35/13-04Q 45 West Lenox St
Chevy Chase Historic District

SUBJECT: Historic Area Work Permit # 344136

HISTORIC PRESERVATION COMMISSION STAFF REPORT

Address:	45 West Lenox Street	Meeting Date:	06/9/04
Applicant:	John & Susan Gorman (Richard M. Guest, Agent)	Report Date:	06/2/04
Resource:	Contributing Resource Chevy Chase Village Historic District	Public Notice:	05/26/04
Review:	HAWP	Tax Credit:	No
Case Number:	35/13-04Q	Staff:	Tania Tully
PROPOSAL:	Window Changes and Portico Replacement		
RECOMMENDATION:	Approval with Conditions

rear view

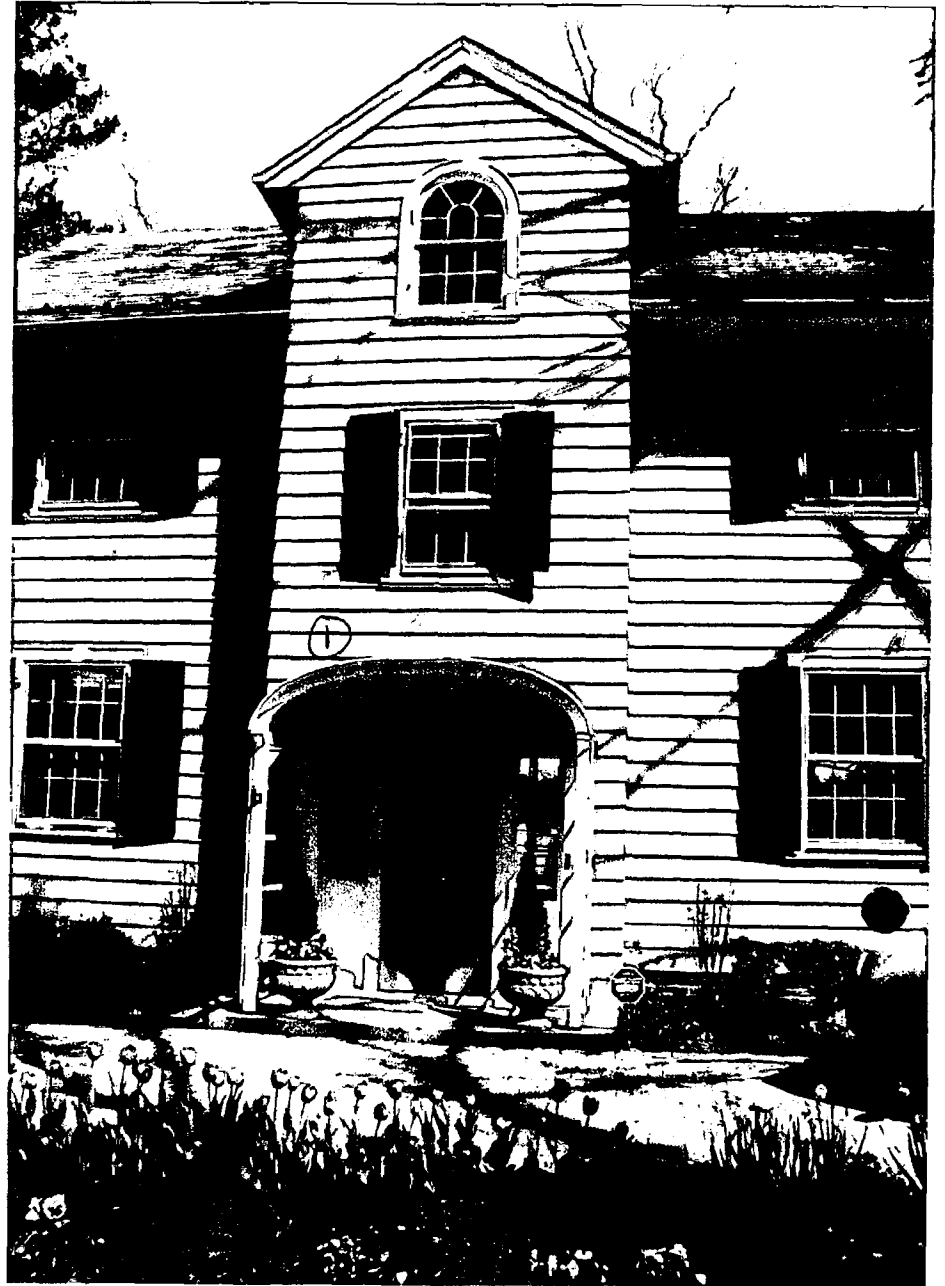
② Replace windows with new wood windows
& open to inside, smaller

Replace Portico with more
traditional look

45 West Lenox St.

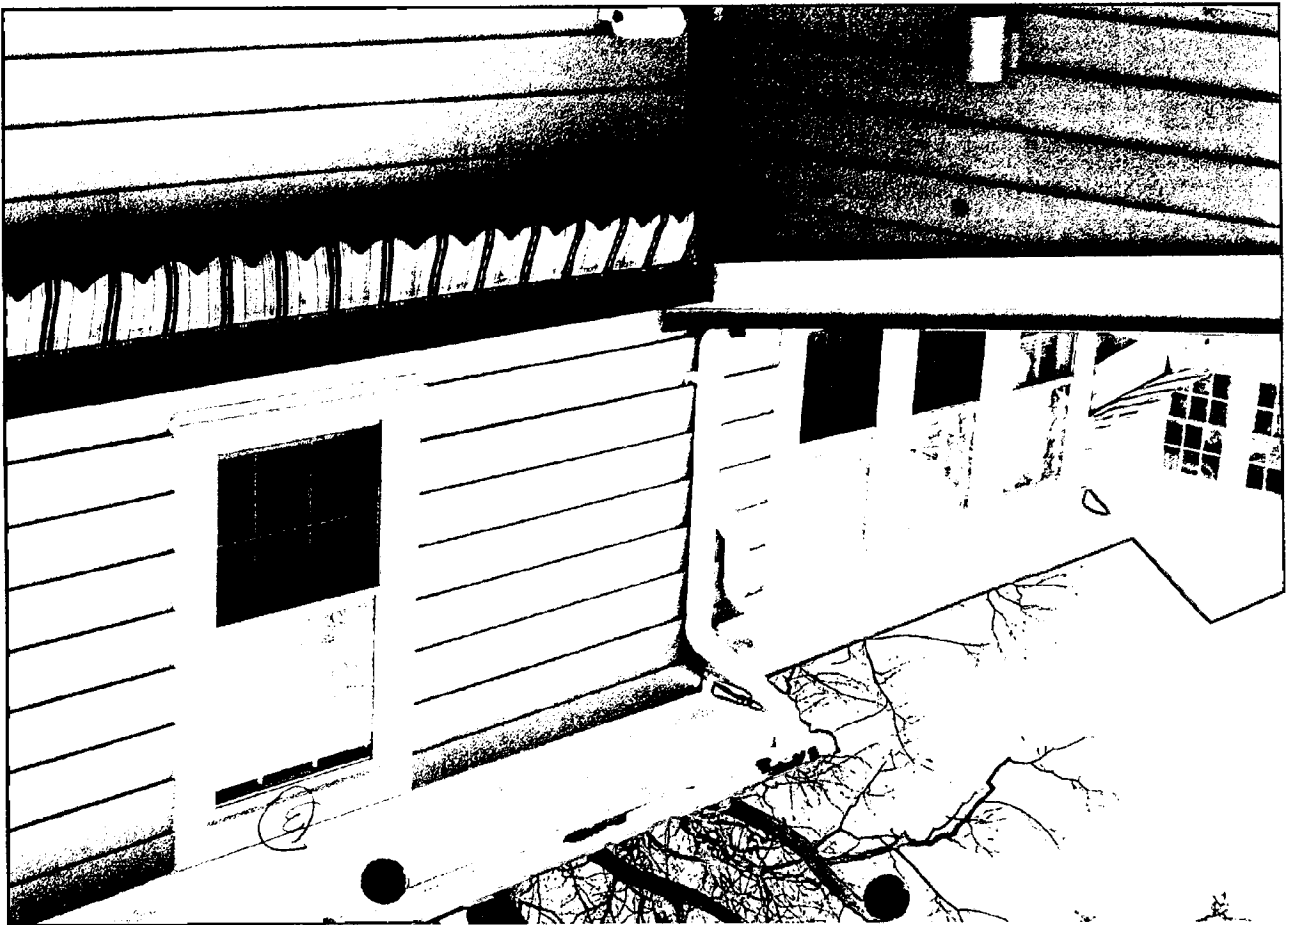
② Replace with square bay window

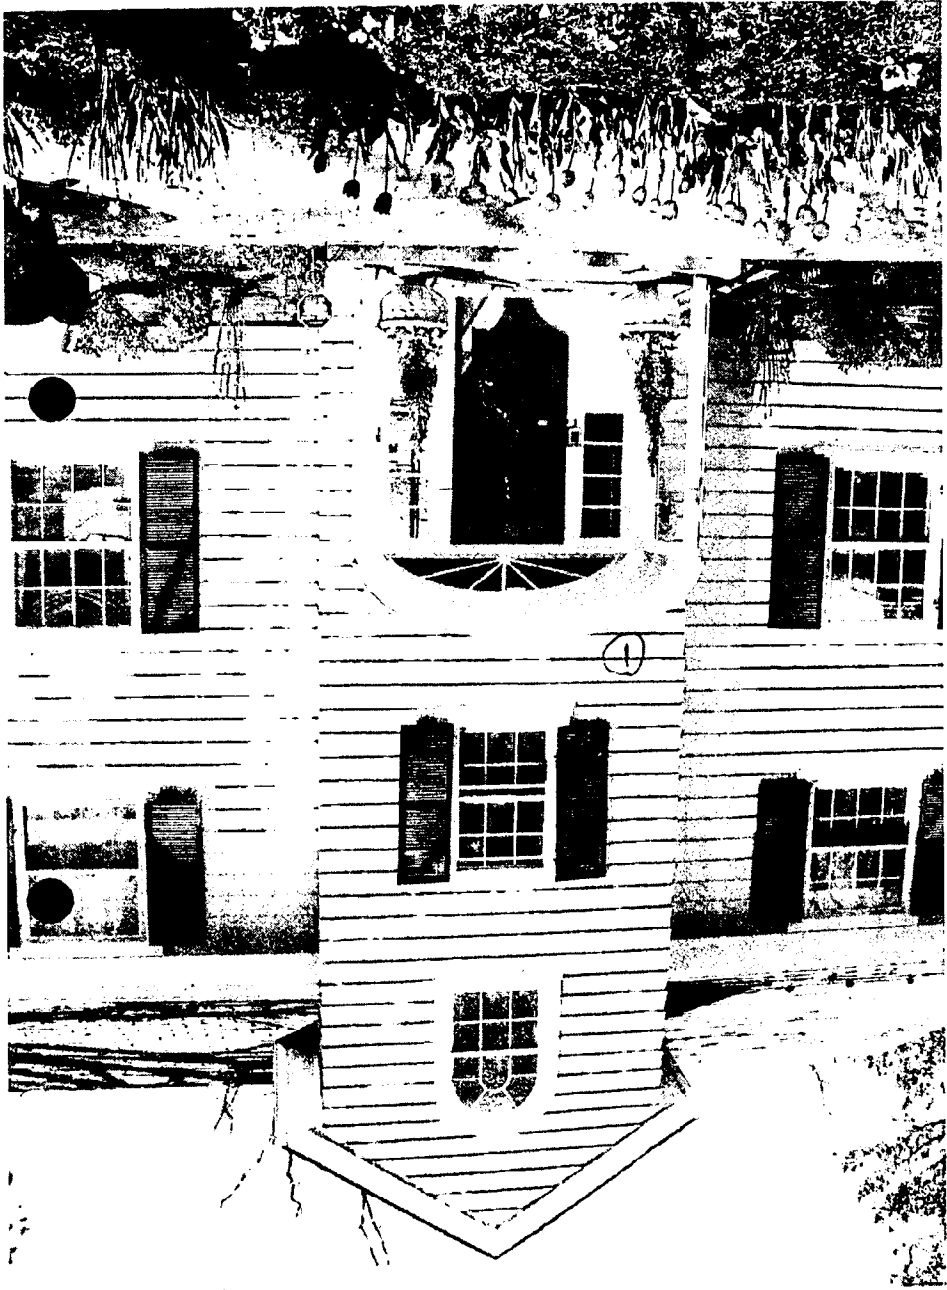
Replace Porches with new
traditional look

Replace windows with new lead windows
& open to inside

45 West Lenox St -

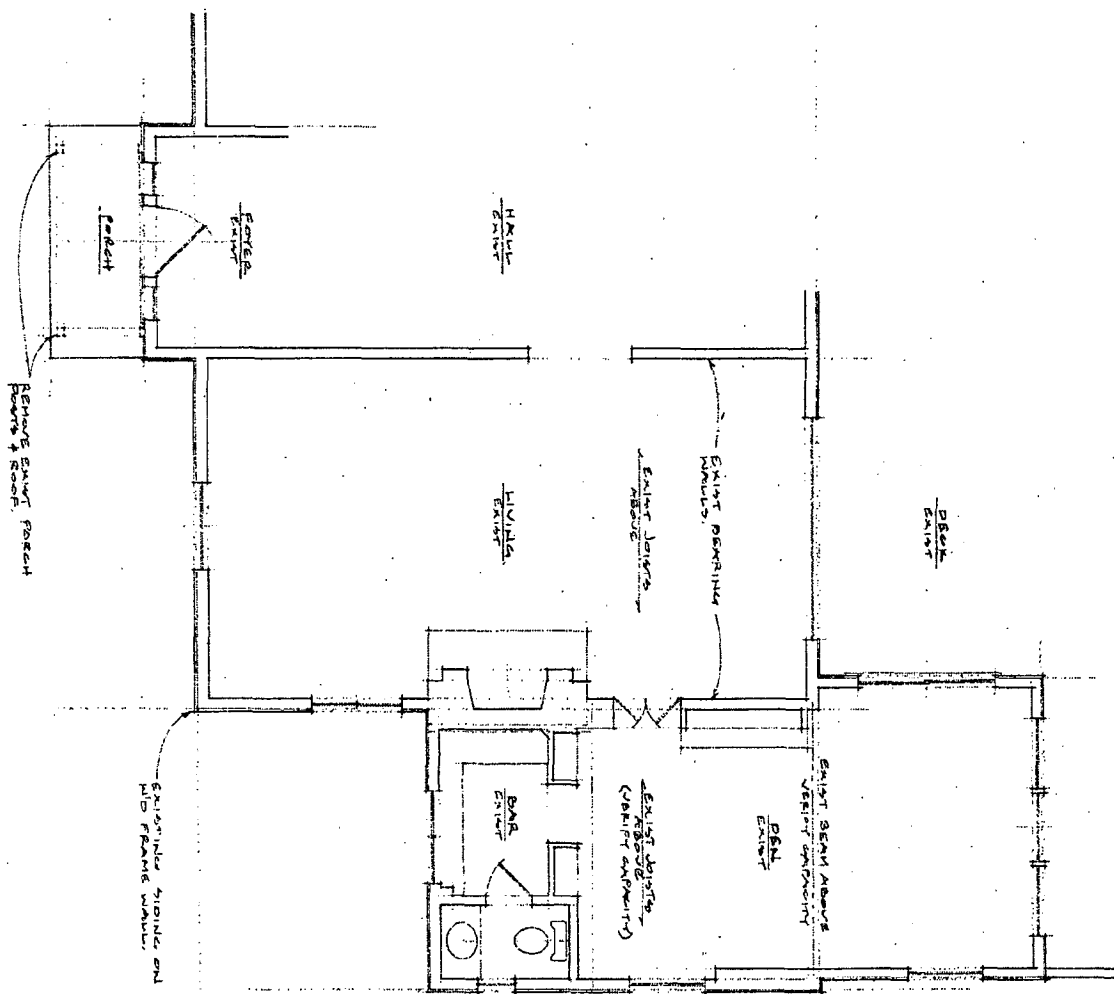
③ Replace with square bay window

RIGHT SIDE ELEVATION
1/8" = 1'-0"
EAST

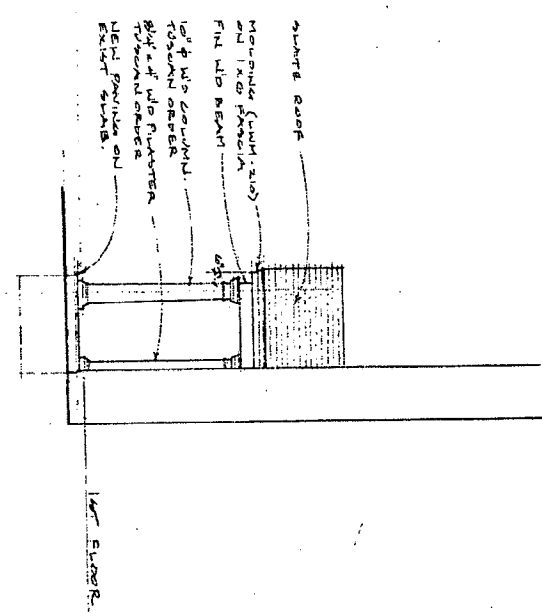
- Replace one window on rear elevation (north) with paired windows in a projecting box bay (circles #15 & #16).
- Rebuild dormer roofs on side elevation (east) with steeper pitch (circles #12, #13 & #14).
- Replace dormer windows on front, east side elevation (circles #15 & #16).

The remaining changes are motivated by the master bedroom and bath remodel. The change in the slopes of the dormer roofs is to make room for the clerestory windows that would replace the three existing windows on the right-side elevation. Currently four of the windows in the bathroom are covered on the interior by a tile wall and a shower stall and would remain so in the new design. Staff understands that the applicants want to maintain privacy and add more light. Staff believes that privacy can be maintained while retaining the existing side windows. Interior window treatments such as decorative shades, blinds, or interior storms with a translucent film could be utilized to maintain the historic features and meet the needs of the applicant. Another option is to leave the windows hidden on the interior, provided that the enclosure provides an adequate moisture barrier. The applicants have expressed a willingness to keep the existing windows and add new windows above them to provide the additional light. Provided that the applicant will work with staff to redesign the new windows, staff believes that it is an approvable solution.

1. The front dormer windows are retained.
2. The Applicant works with staff to explore retention of the east side windows.
3. The clerestory windows are redesigned.
